N1996A-03

S E R V I C E N O T E

N1996A Agilent CSA Spectrum Analyzer

DIF FPGA Upgrade Failure While Upgrading to >= A.02.00 Firmware

Figure 1. A4 Digital IF Assembly – Location of A4J4 JTAG connector and A4R315.

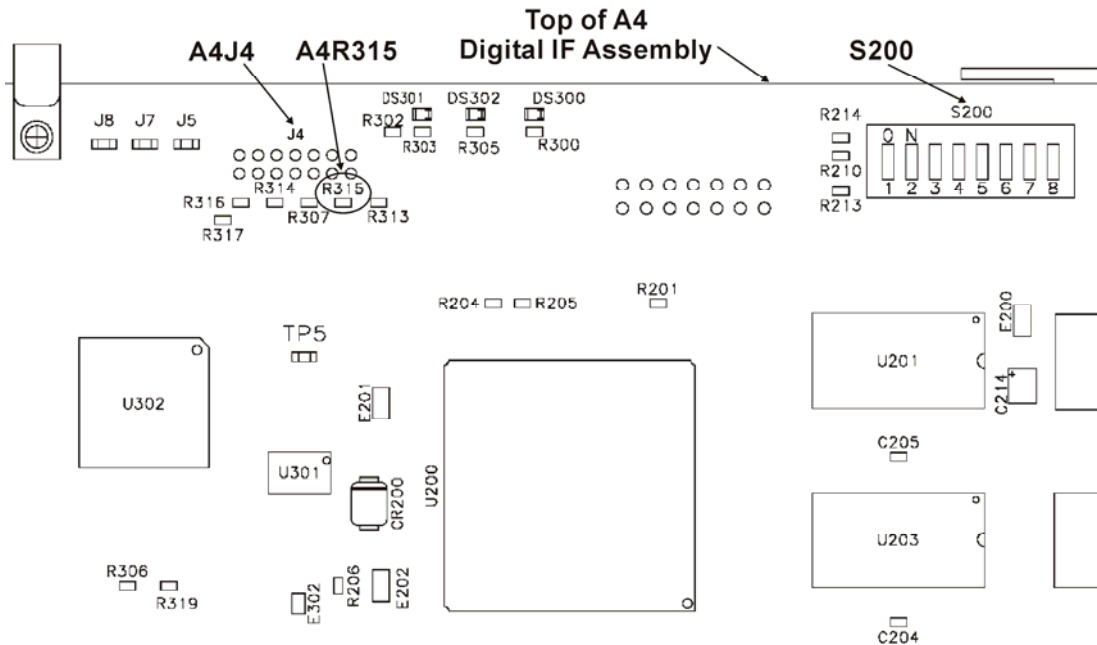
N1996A spectrum analyzers with serial numbers US/MY/SG46490000 and above have a newer A4 DIF board, p/n N1996-60033, which have a lower value for R315 which prevents the glitches from occurring.

Also, by changing the value of R315 on the A4 DIF board to 75 Ohms, this problem will be avoided in the future. The resistor part number is 0699-3921.

The programming cable requires the A4 DIF board to have diagnostic connector J4 loaded. Early A4 DIF boards have this connector loaded but later boards do not. Therefore, it may be necessary to also load J4 with p/n 1253-6145.

2. Remove the analyzer's board cover as described in the Board Cover, Removal procedure in the N1996A Service Guide.
3. Remove A4 DIF assembly as described in the A4 IF Board, Removal procedure in the N1996A Service Guide.
4. Refer to Figure 1 below to locate A4R315. Remove A4R315 and replace it with a 75 Ohm resistor, p/n 0699-3921.
5. Refer to Figure 1 below. If J4 is not loaded, install a 14-position, right-angle connector header, p/n 1253-6145, in the space provided for J4.
